MFN 06-407
Supplement 13

Subject: Revised Response to Portion of NRC RAI Letter No. 166 Related to ESBWR Design Certification Application - DCD Tier 2 Section 3.8 – Seismic Category I Structures; RAI Number 3.8-94, Supplement 3

Revised Response to Portion of NRC RAI Letter No. 166

RAI Number 3.8-94 S03 (Revision 1)

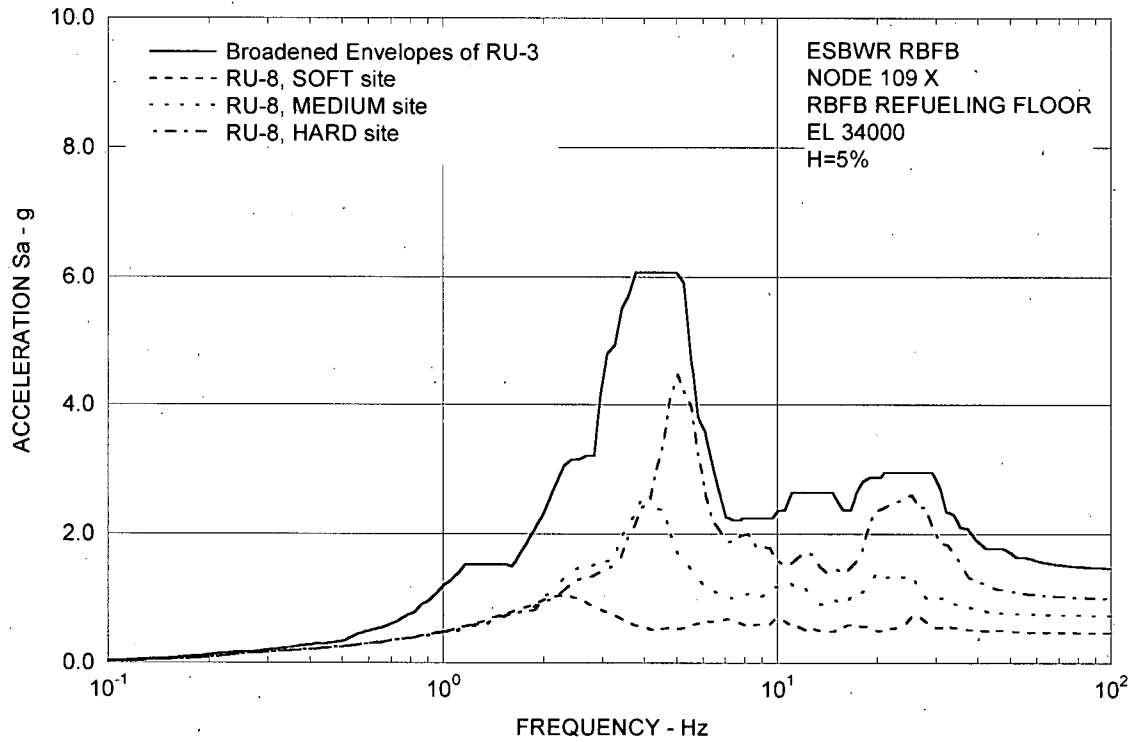
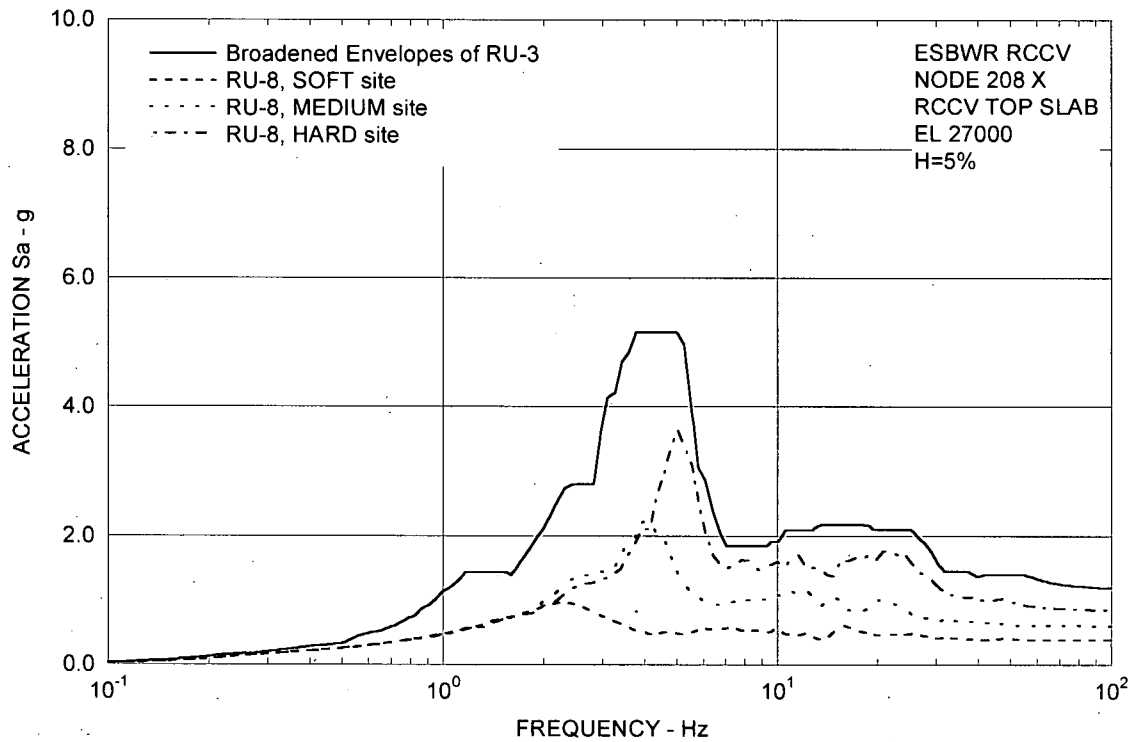
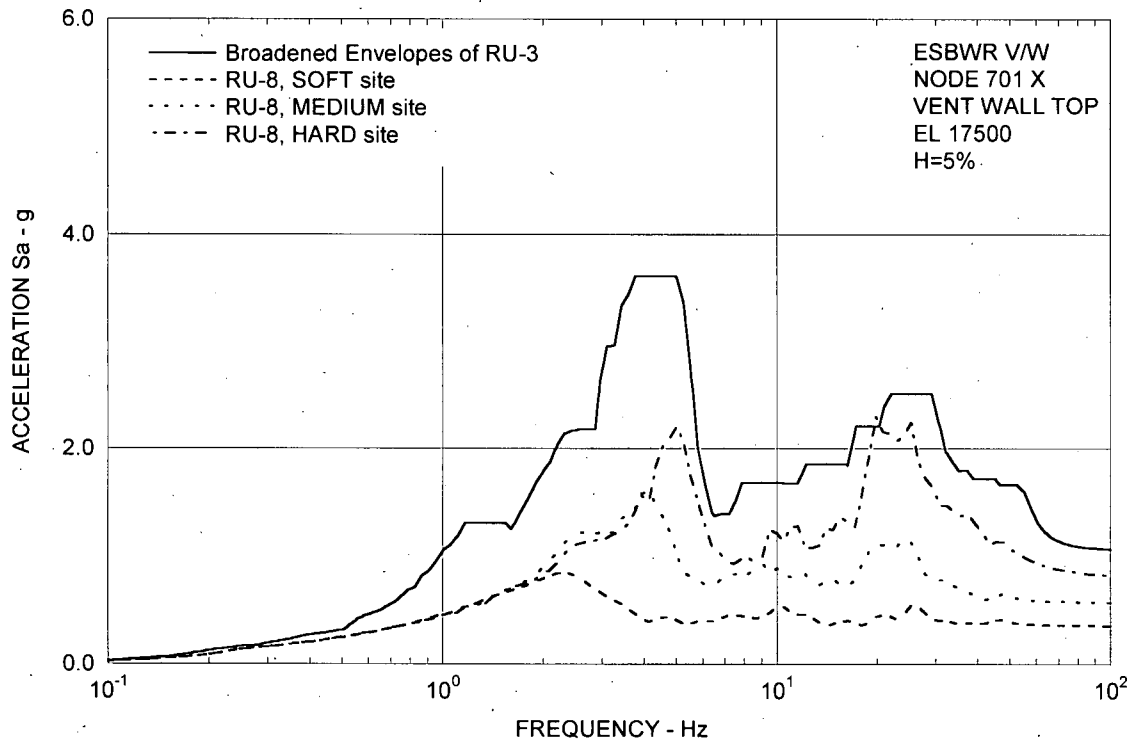
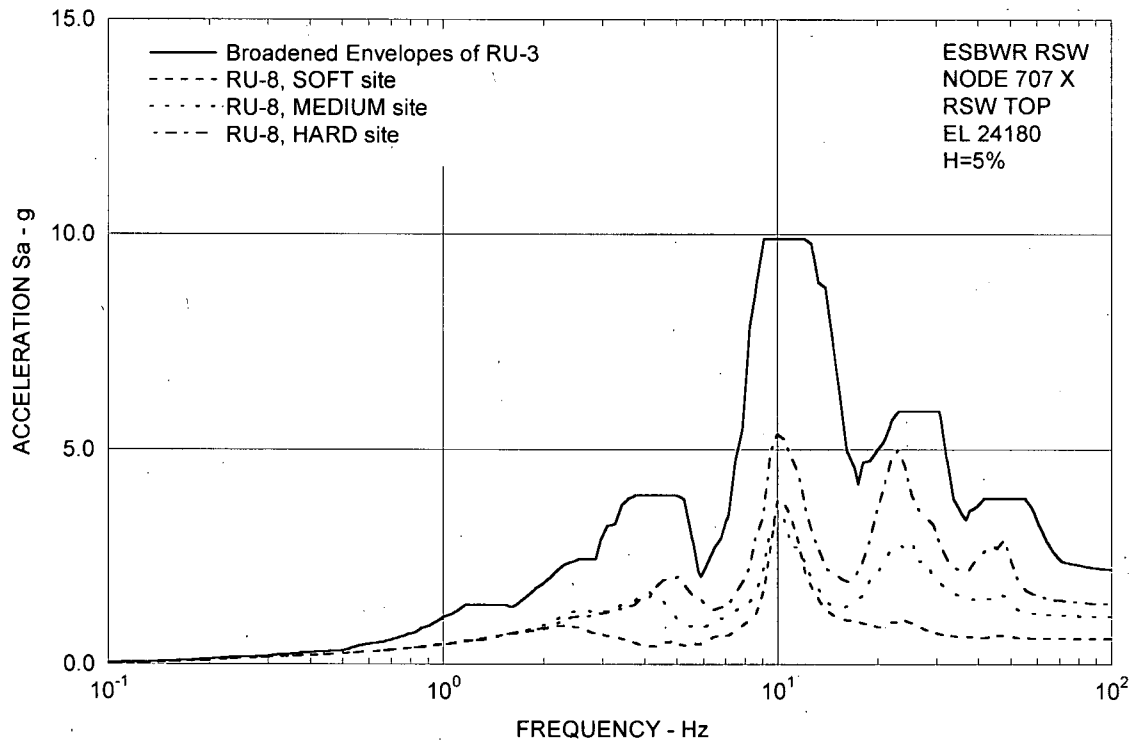
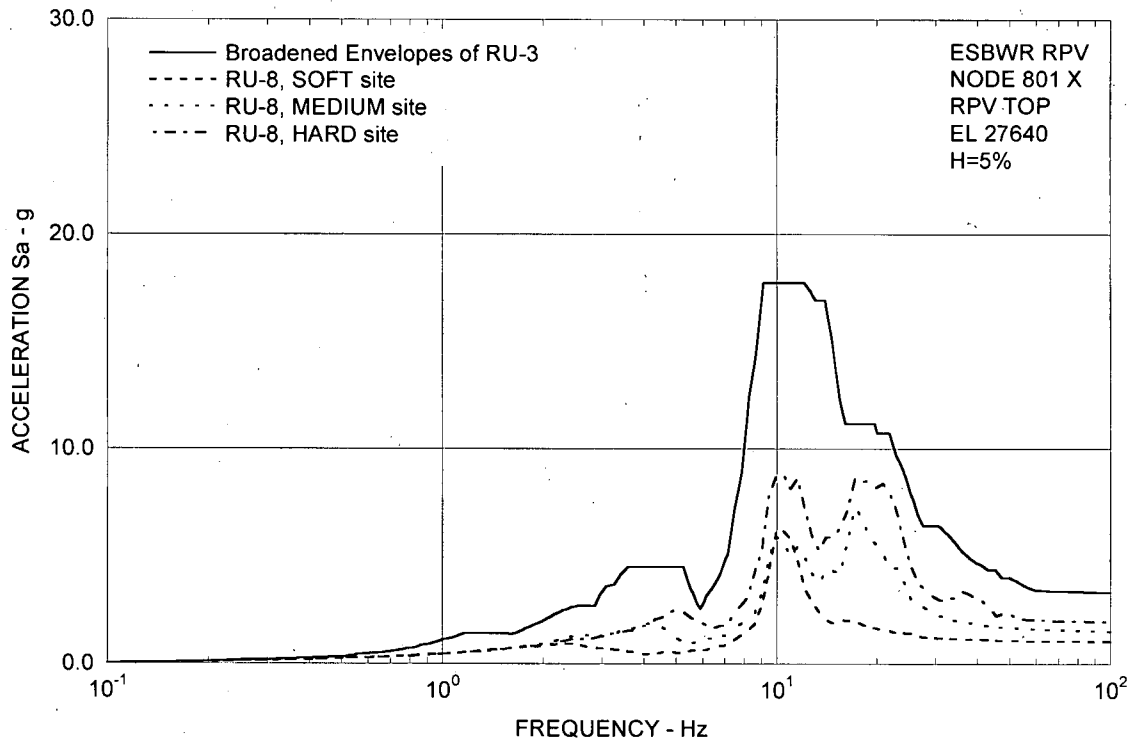
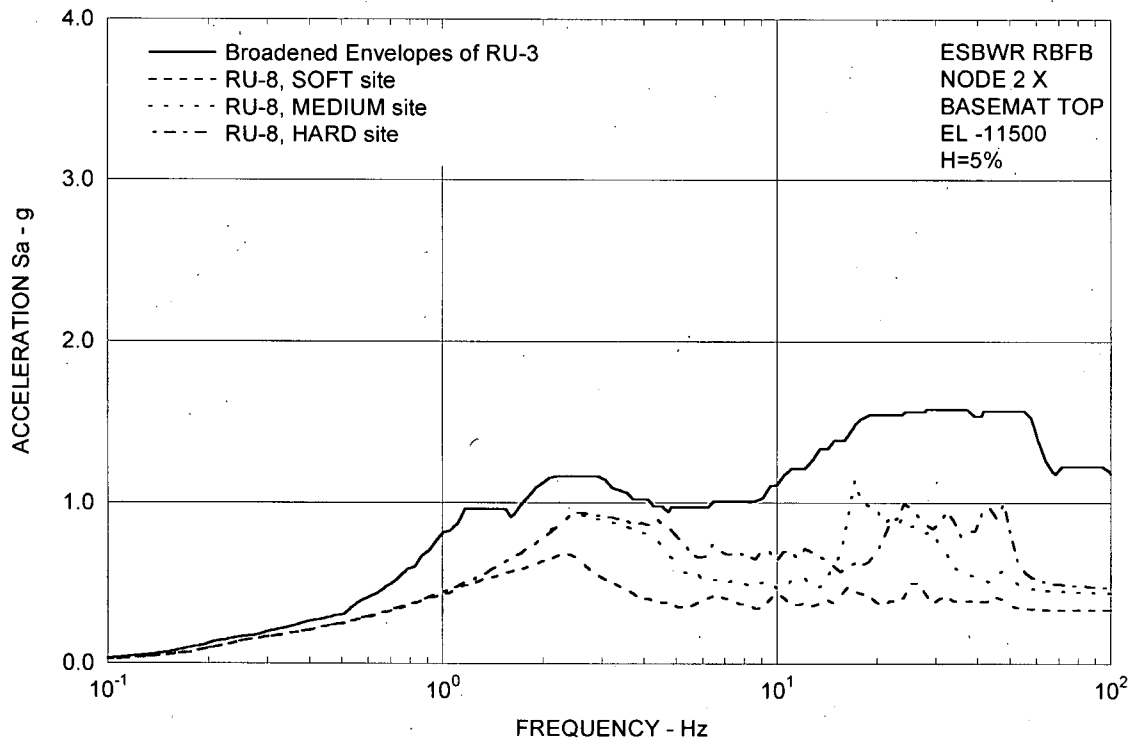
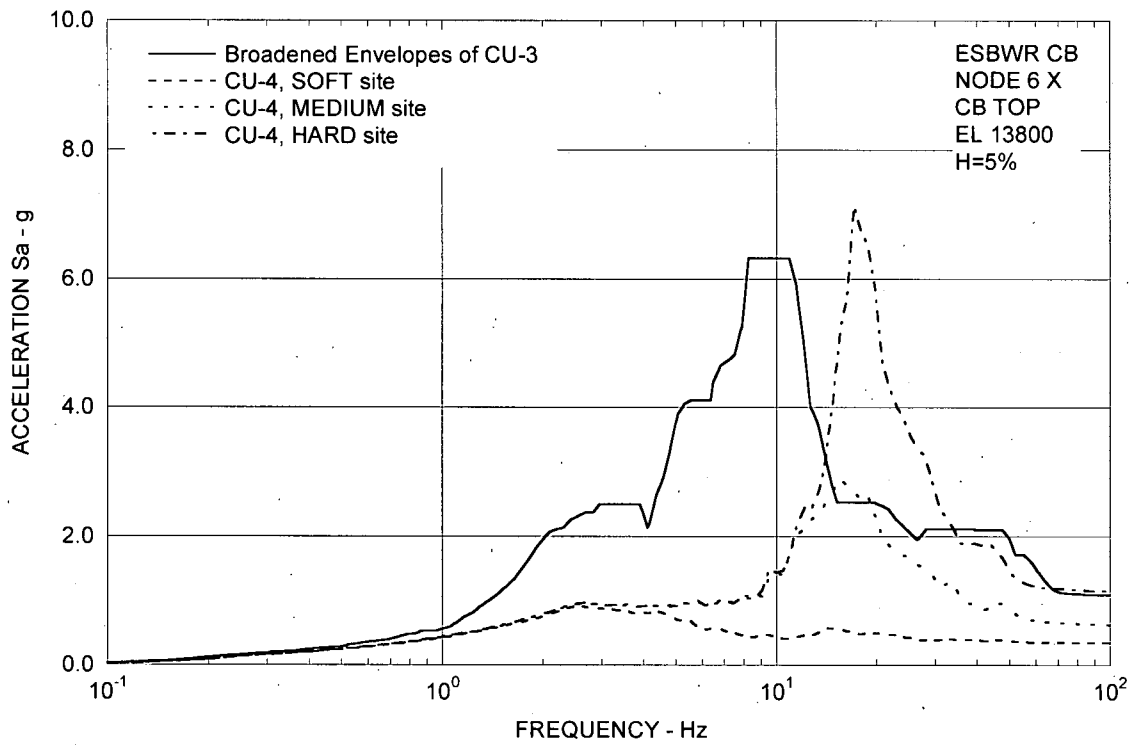
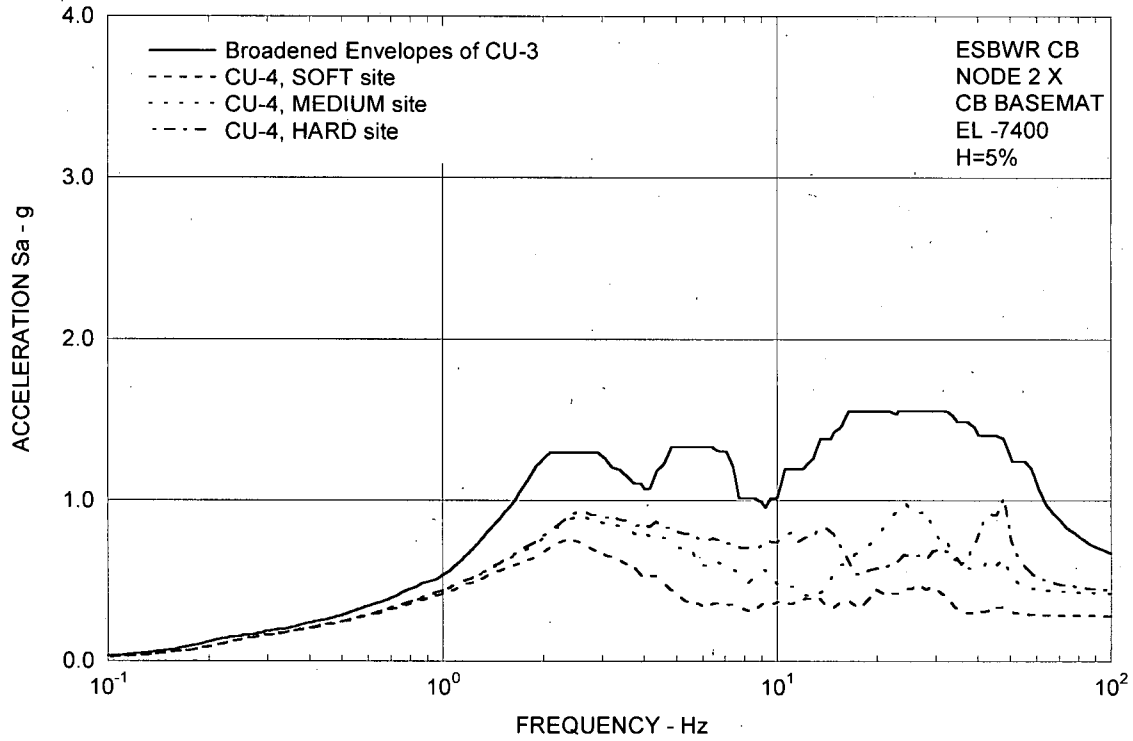
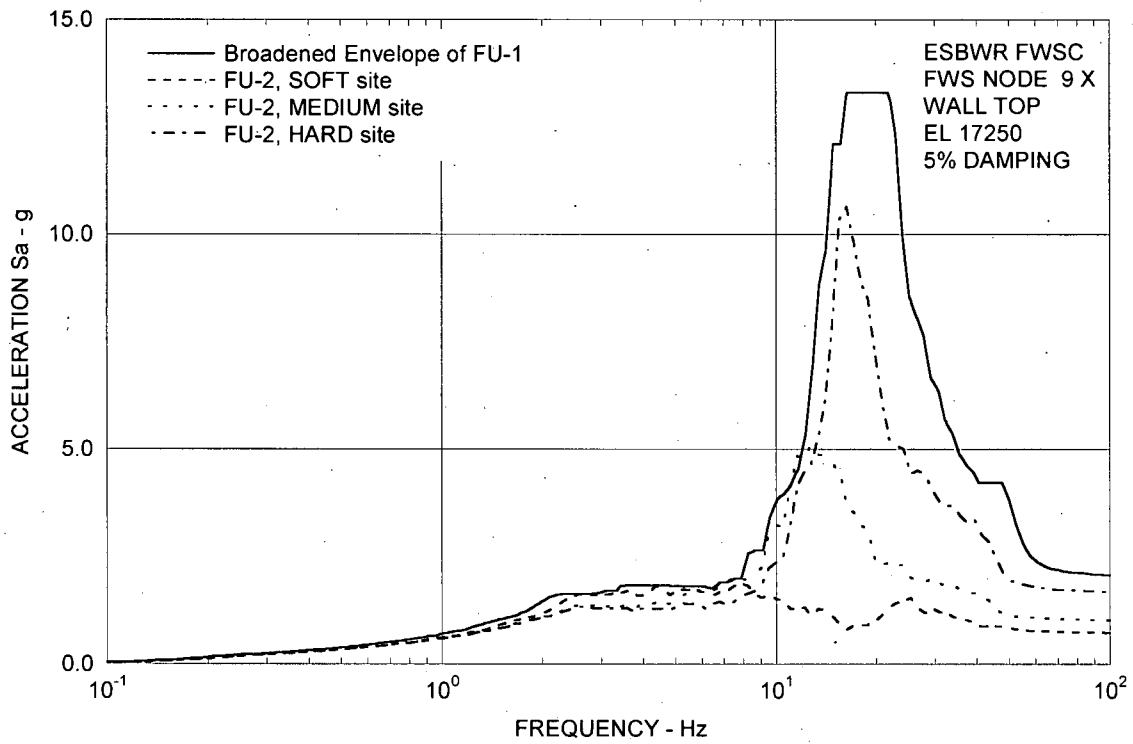
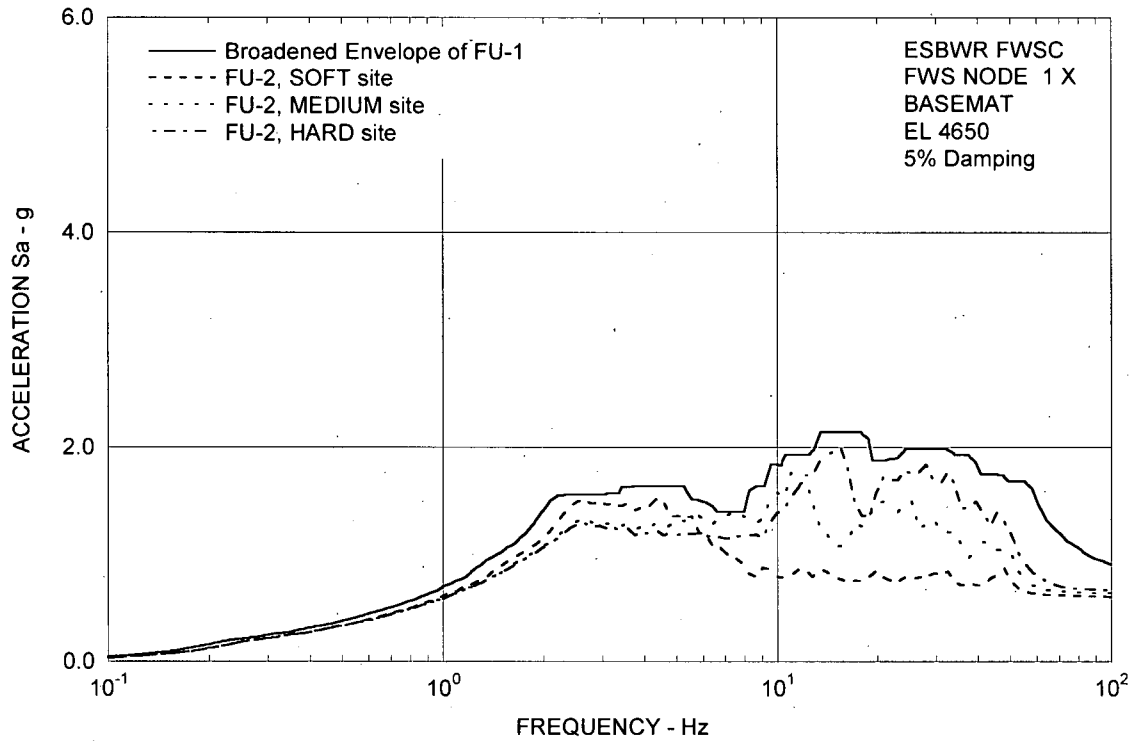
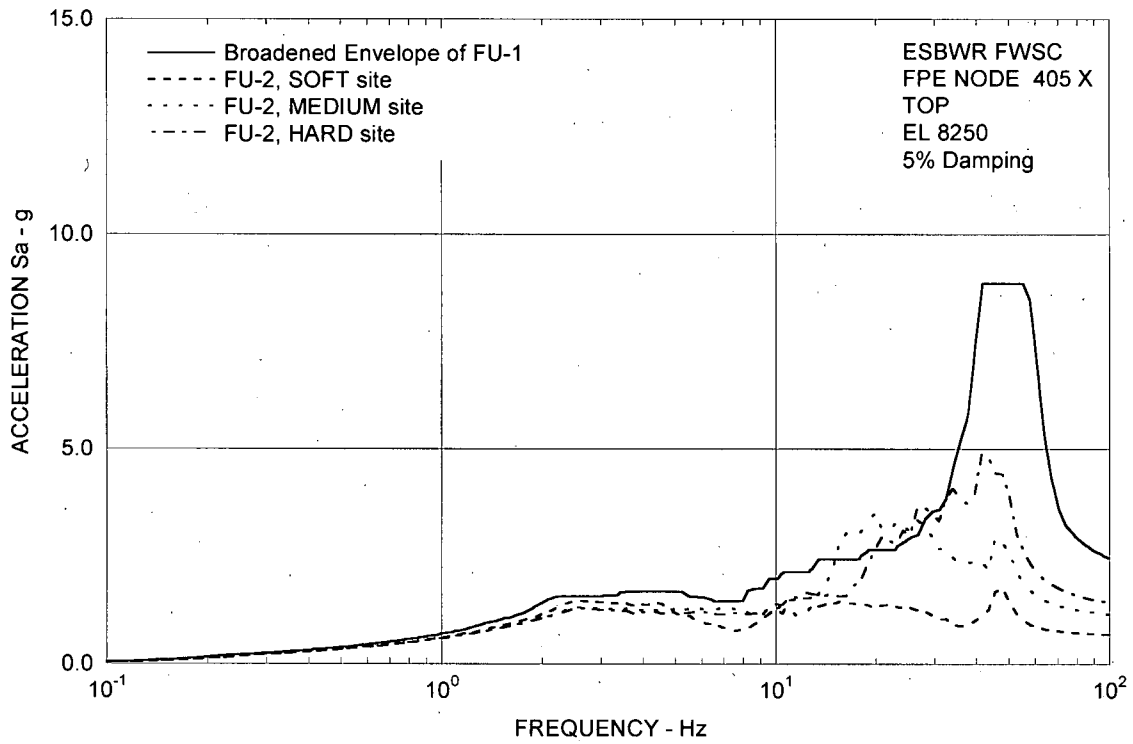
Comparisons of the response spectra are shown in Figures 3.8-94(4) through 3.8-94(15), Figures 3.8-94(16) through 3.8-94(27), and Figures 3.8-94(28) through 3.8-94(39), respectively for the X direction, Y direction, and Z direction. These comparisons will be added in DCD Revision 6 as DCD Tier 2 Figures 3A.8.7-1a through 3A.8.7-3l.

As for the RB/FB, it is found from the results that the responses for the SASSI2000 uniform cases are bounded by the broadened envelope responses of the DAC3N cases in the whole frequency range. The responses of the RU-8 uniform hard site at the vent wall top (X direction per Figure 3.8-94(6)) and the refueling floor (Z direction per (Figure 3.8-94(28)) at around 20 Hz are slightly higher around 20 Hz but the exceedance is negligibly small.

On the other hand, the response spectra of a portion of the CB above ground and the FPE in the FWSC exceeded greater than 10% at the broadened envelope responses of the DAC3N cases in the higher frequency range.

Thus, the SASSI2000 uniform site results of the CB and the FWSC are included where appropriate to obtain the enveloping design spectra. DCD Tier 2 Figures 3A.9-1g, 3A.9-1l, 3A.9-2g and 3A.9-3g will be revised in Revision 6 accordingly.
